Office Action Summary

10/634,235

BERNHARDT, PETER

DETAILED ACTION

Epp et al., 5,882,137

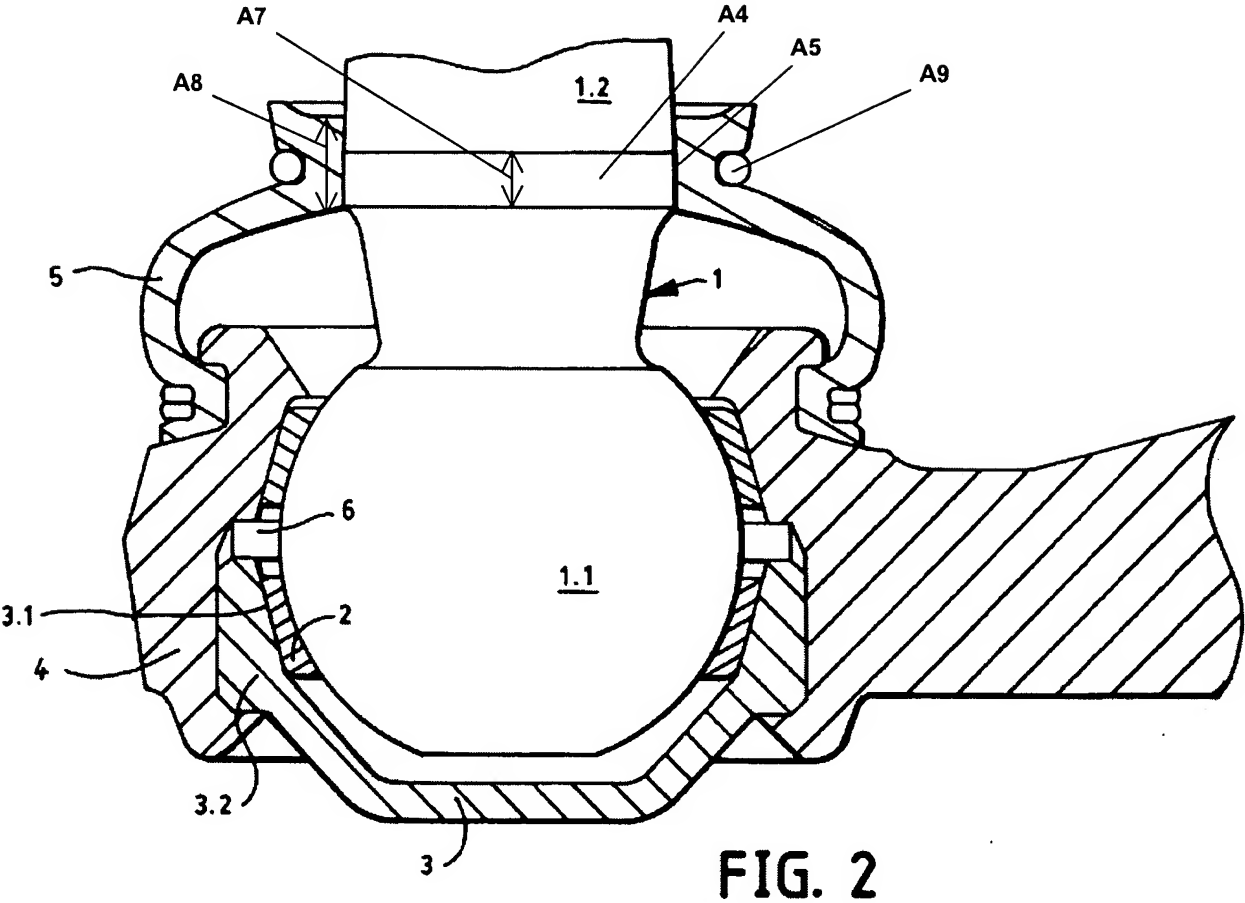
Claims 6 and 8 are rejected under 35 U.S.C. 102(b) as being anticipated by Epp et al., 5,882,137 (see marked-up attachment).

Regarding claim 6, Epp et al. disclose, in Figure 2, a ball joint including a housing 4, a ball stud 1, and a sealing bellows 5. The sealing bellows 5 lies against the housing 4 and the ball stud 1. The ball stud 1 has a holding surface A5 against which a sealing surface A6 of the sealing bellows 5 lies. The sealing surface A6 defines a first axial dimension A7. The holding surface A5 defines a second axial dimension A8. The first axial dimension A7 is greater than the second axial dimension A8.

Regarding claim 8, the sealing bellows 5 is provided with a metal ring A9 urging the sealing surface A6 against the holding surface A5.

Regarding claim 12, Epp et al. disclose, in Figure 2, a ball joint including a housing **4**, a ball stud **1**, and a sealing bellows **5**. The sealing bellows **5** lies against the housing **4** and the ball stud **1**. The ball stud **1** has a holding surface **A5** against which a sealing surface **A6** of the sealing bellows **5** lies. The sealing bellows **5** is provided with

a metal ring **A9** urging the sealing surface **A6** against the holding surface **A5**. The sealing surface **A6** defines a first axial dimension **A7**. The holding surface **A5** defines a second axial dimension **A8**. The first axial dimension **A7** is greater than the second axial dimension **A8**. However, Epp et al. fail to disclose the holding surface **A4** and the sealing surface **A5** being cylindrical. Applicant should note that the courts have consistently held that a change in the shape of a prior art device is a design consideration within the skill of the art. In re Dailey, 357 F.2d 669, 149 USPQ 47 (CCPA 1966). Further, since there is no criticality for making the holding surface and the sealing surface cylindrical, it would have been obvious to choose any mating surface configuration. In any case, the German patent, in Figure 2, or Dorr et al., in Figure 1, provides evidence that a holding surface and the sealing surface are known to be cylindrical. Accordingly, it would have been obvious to make the holding surface and the sealing surface in Epp et al. cylindrical instead of conical as both configuration have been equally known to provide a sealing interface.

Fig. 2

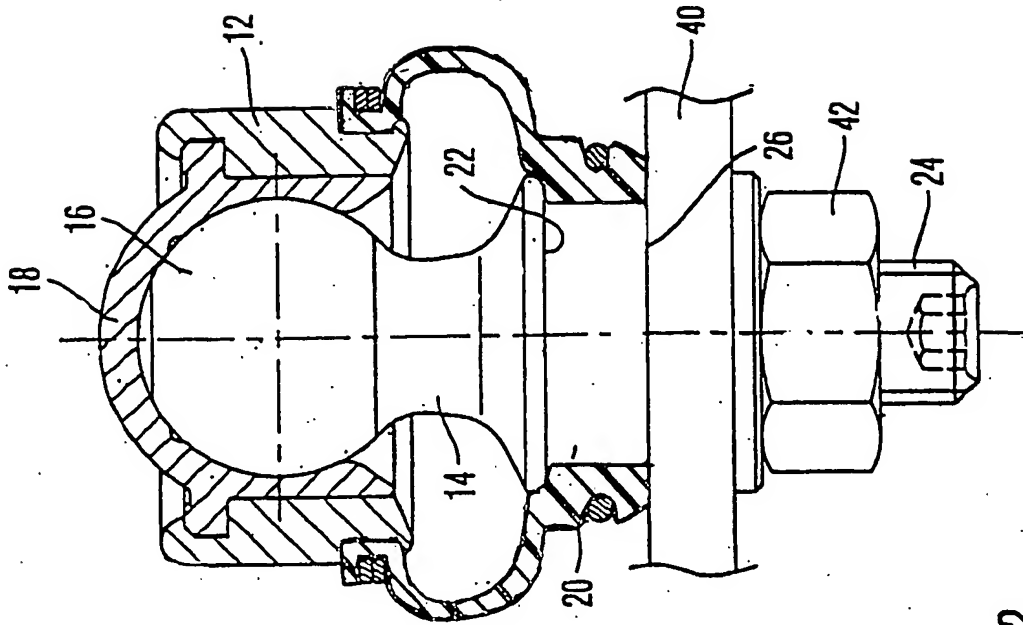
same contact surface in Figure 1. Reference character "20" should be shown as in Figure 2.

The drawings are objected to because the lead lines of reference characters 22 (Fig. 1), 30, and 20 (Fig. 2) does not completely extend to the location the references characters represent. See scanned drawings in the PAIR system.

Corrected drawing sheets in compliance with 37 CFR 1.121(d) are required in reply to the Office action to avoid abandonment of the application. Any amended replacement drawing sheet should include all of the figures appearing on the immediate prior version of the sheet, even if only one figure is being amended. The figure or figure number of an amended drawing should not be labeled as "amended". If a drawing figure is to be canceled, the appropriate figure must be removed from the replacement sheet, and where necessary, the remaining figures must be renumbered and appropriate changes made to the brief description of the several views of the drawings for consistency. Additional replacement sheets may be necessary to show the renumbering of the remaining figures. The replacement sheet(s) should be labeled "Replacement Sheet" in the page header (as per 37 CFR 1.84(c)) so as not to obstruct any portion of the drawing figures. If the examiner does not accept the changes, the applicant will be notified and informed of any required corrective action in the next Office action. The objection to the drawings will not be held in abeyance.

Fig. 1

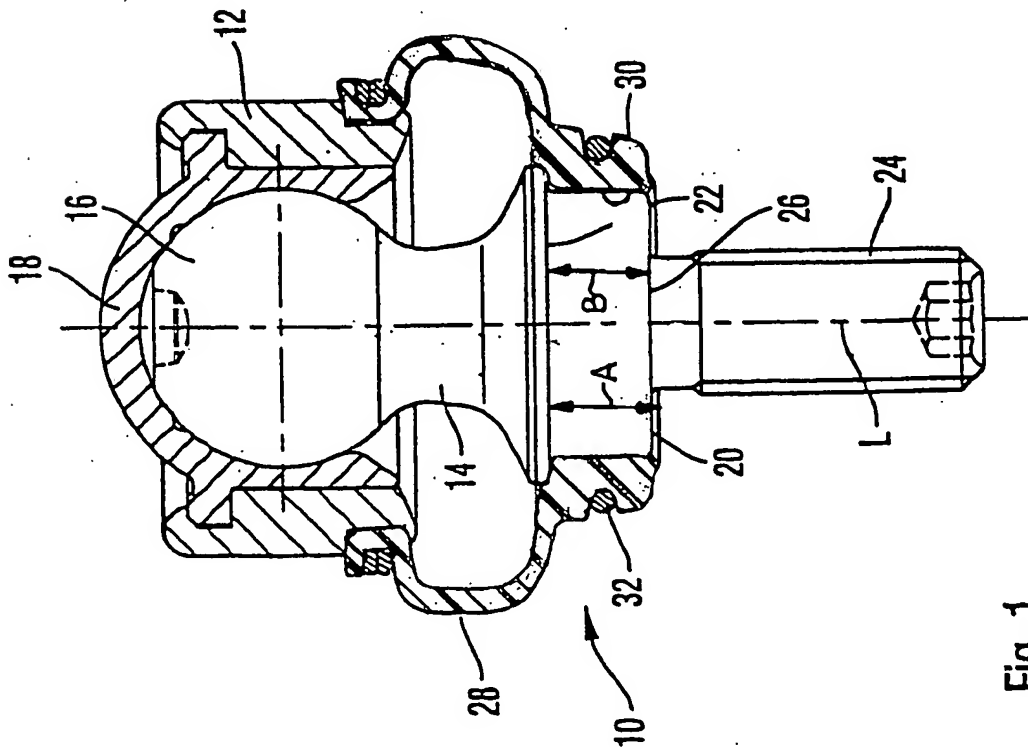
The drawings are objected to as failing to comply with 37 CFR 1.84(p)(4) because reference characters "20" and "26" have both been used to designate the
